**Project Name:** 6000 SQ FT BUILDING

**Project Description:** Danforth Street - 501; 6000 Sq Ft Accessory Building; Propsys, Inc.

**RE:** Review Comments for Final Plan – Administrative Review

**Subject: 501 Danforth Street Accessory Building  
Response to Administrative Review Comments Dated March 26, 2010**

PROJECT  
**ACCESSORY BUILDING**  
**501 DANFORTH STREET**  
 SHEET TITLE  
**SITE LAYOUT AND UTILITY PLAN**

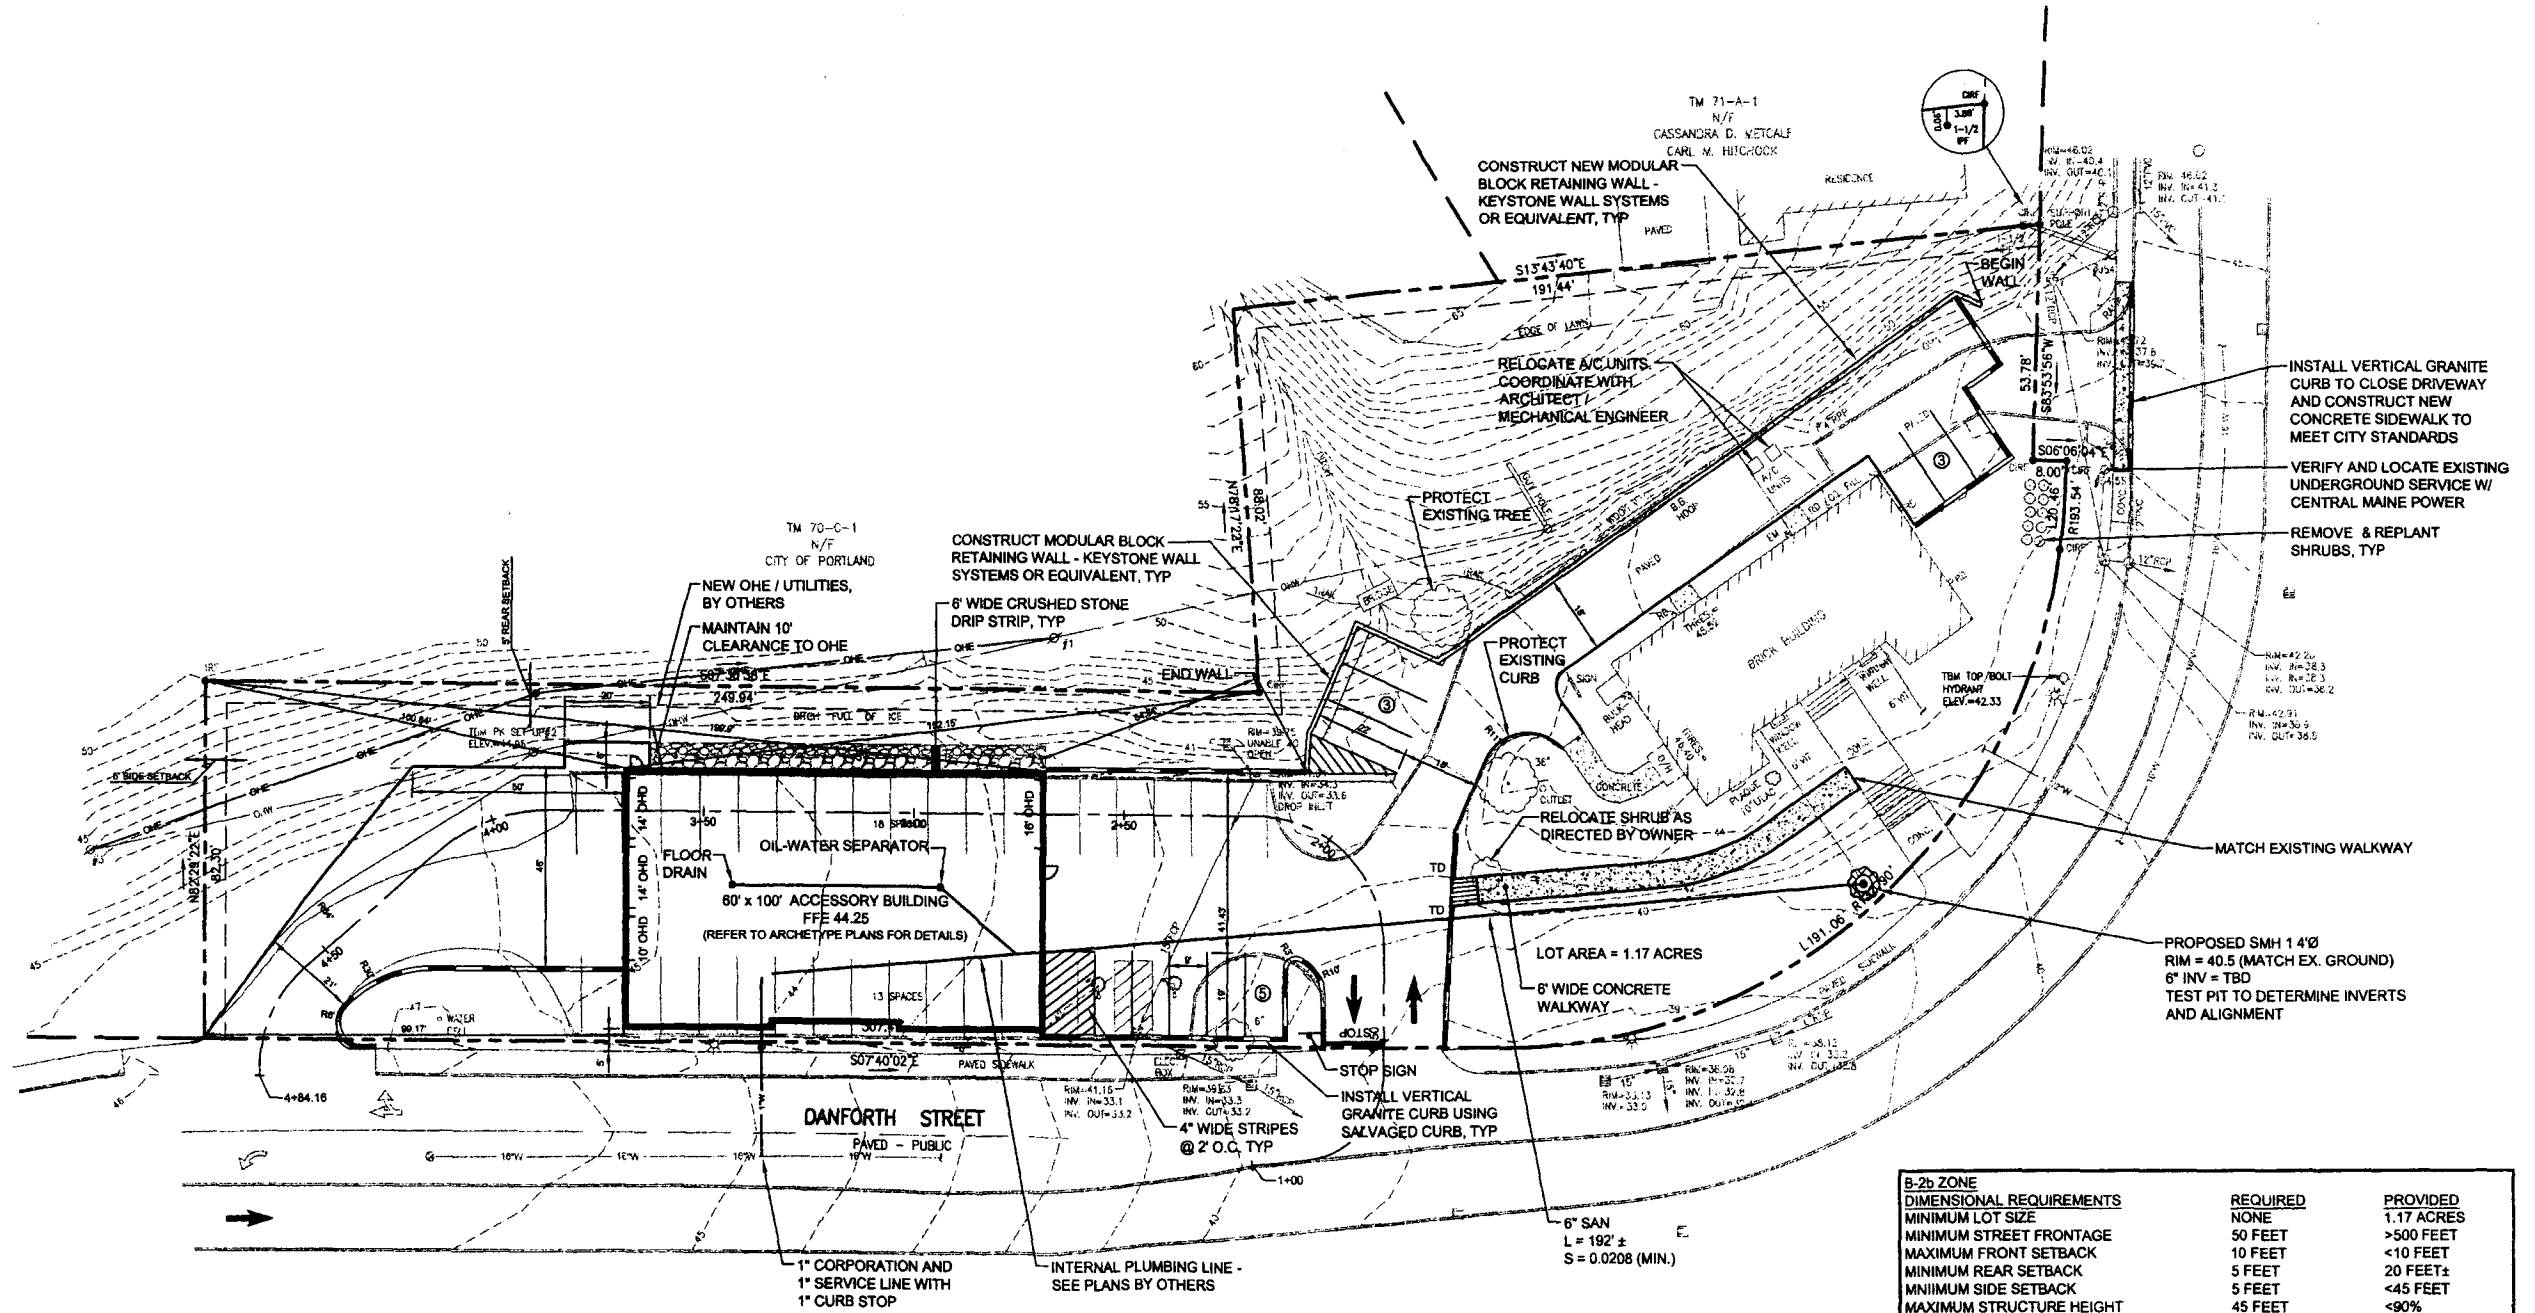
I noticed that the submitted site plans show a Zoning analysis block that is not correct. That block that shows up in several places must be corrected.

*I noticed that the submitted site plans show a Zoning analysis block that is not correct. That block that shows up in several places must be corrected.*

DeLuca-Hoffman Associates, Inc. has revised the Zoning Analysis table provided on the site plans. This is shown on the accompanying plans.

**(D) TYPE 1 VERTICAL GRANITE CURB DETAIL**  
ONSITE AREAS ONLY  
N.T.S.

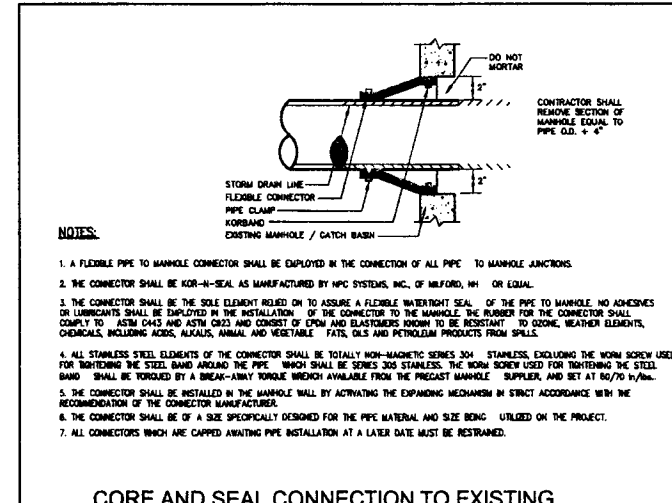
5. City standard details for concrete sidewalks and concrete sidewalks and granite curbing. Construction within the street right of way shall follow these standards.

Notes requiring that the concrete sidewalk and granite curb meet the City technical standards are identified on the project plans.
